CITY OF CAMBRIDGE  
BUILDING DIVISION

WILLOW 1 (GR)  
ELEVATION 1, 2 & 3

TITLE SHEET  
BARLASSINA CONSTRUCTION  
CITY OF CAMBRIDGE

MODEL:	
	WILLOW 1	
	SCALE:	
	3/16"= 1'-0"	
PROJ. No.	DWG. No.	
	21-35	0

INVERTED STEEL ANGLE DETAIL

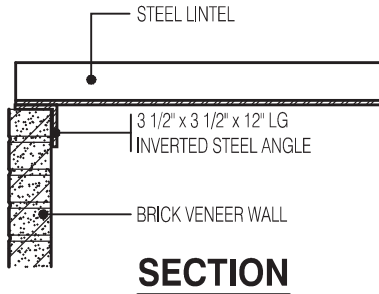
INSTALLATION OF FLUSH STEEL BEAMS SHALL CONFORM TO THE REQUIREMENTS OF 9.23.9.2.(3), (4) & (5)

BASEMENT PLAN EL-3  
BARLASSINA CONSTRUCTION  
CITY OF CAMBRIDGE

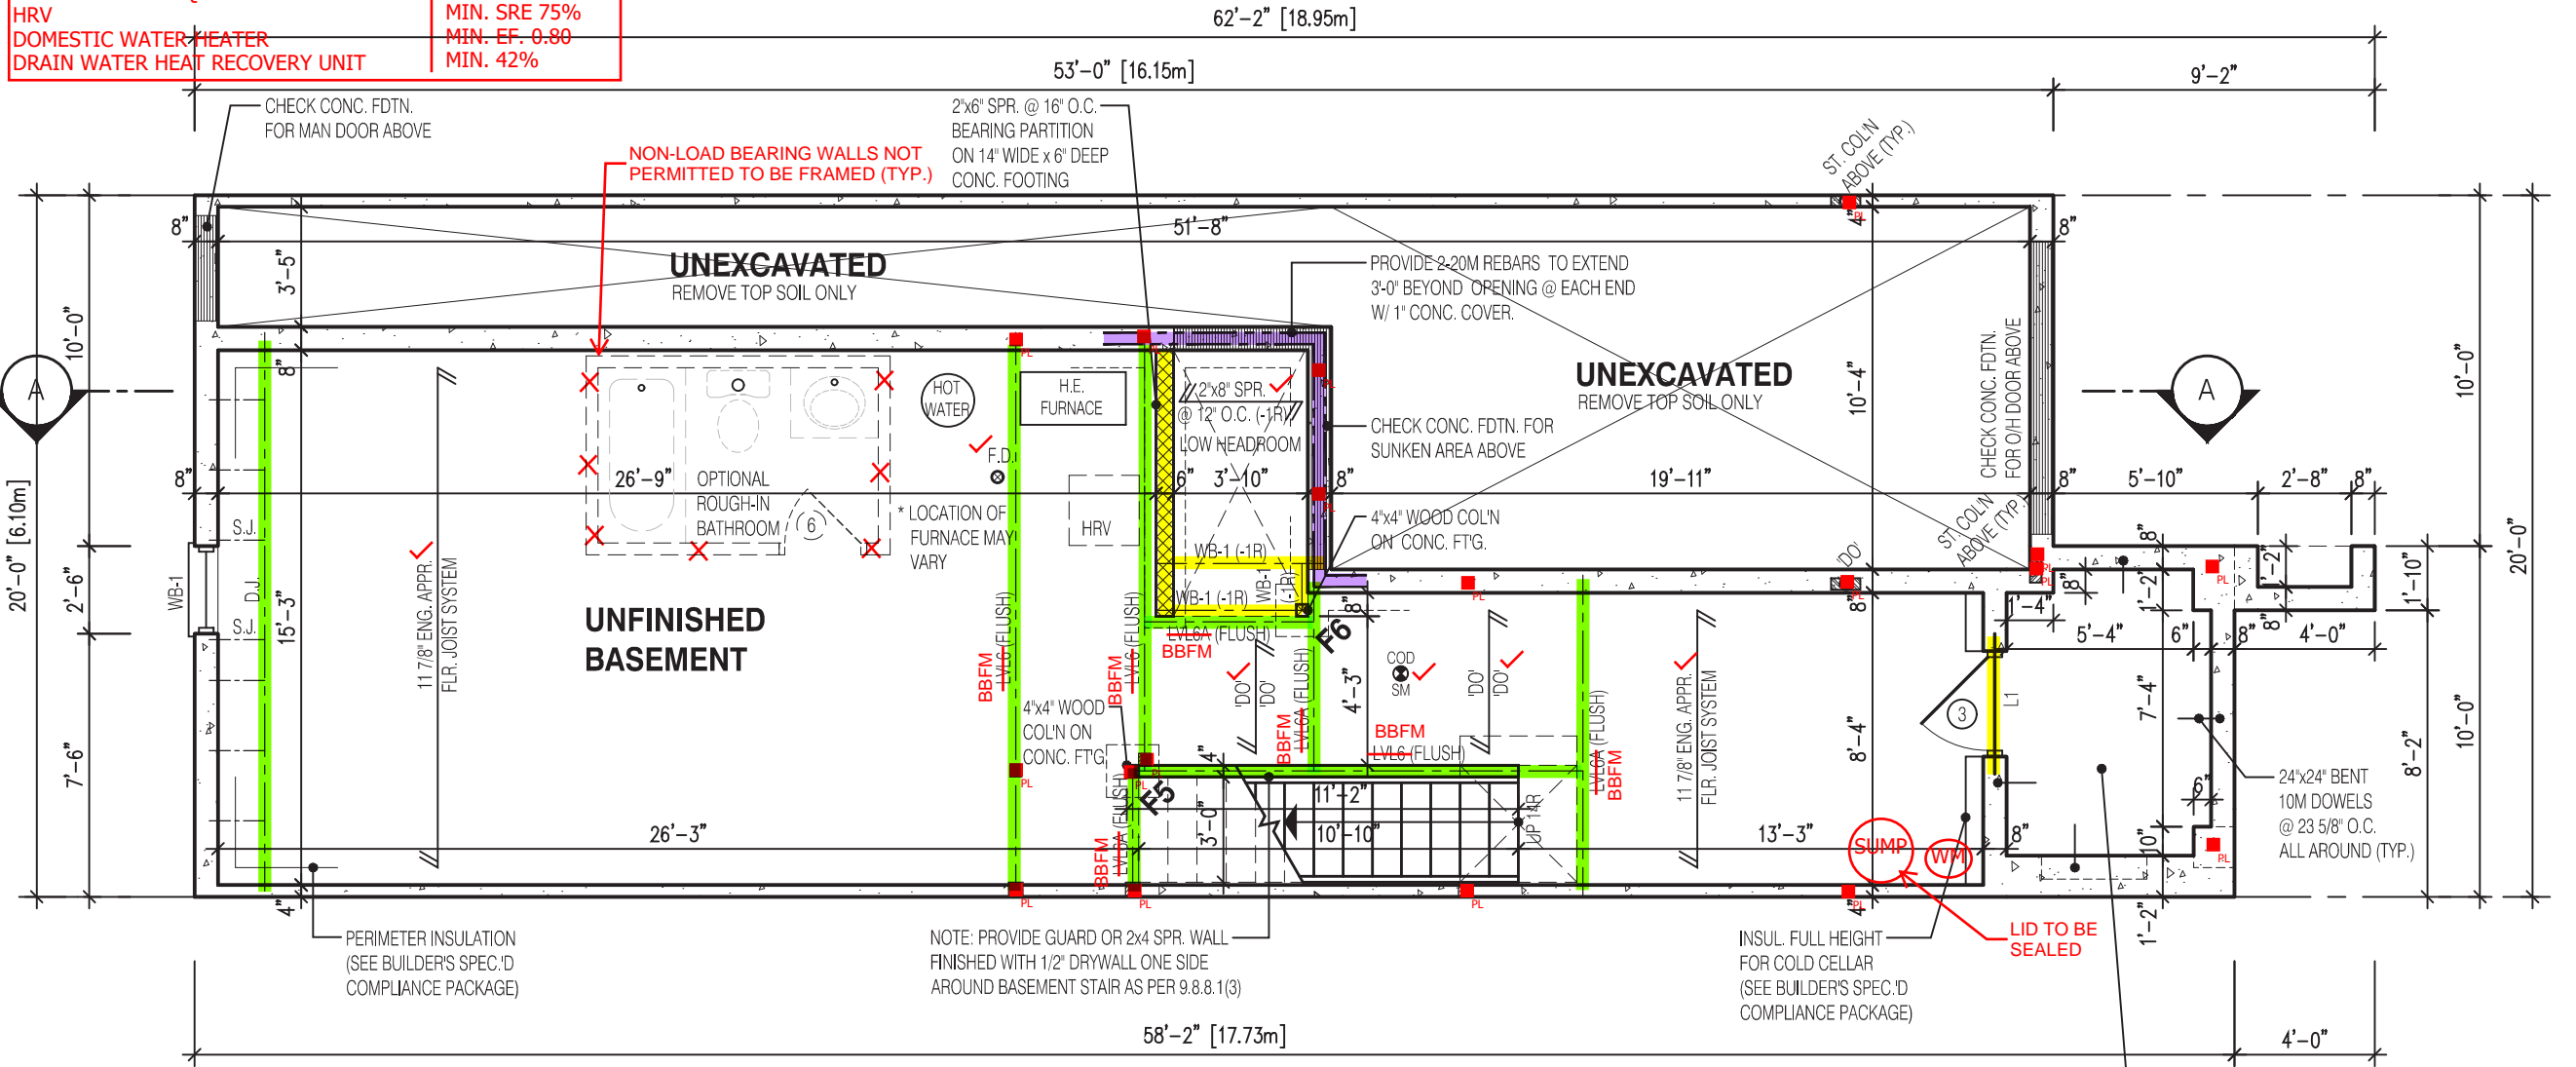
VERIFY WATER METER AND DWHR  
UNIT LOCATION WITH INSPECTOR

SPRAY FOAM/RIGID INSULATION TO BE  
PROTECTED AS PER 9.10.17.10.(1)

WATER METER TO BE INSTALLED WITHIN 2m  
(6'-6") FROM THE POINT THE WATER SERVICE  
PIPE MEETS THE BUILDING LINE

REQUIRED CONTINUOUS INSULATION  
CANNOT BE INTERRUPTED BY FRAMING  
MEMBERS SUCH AS STUDS
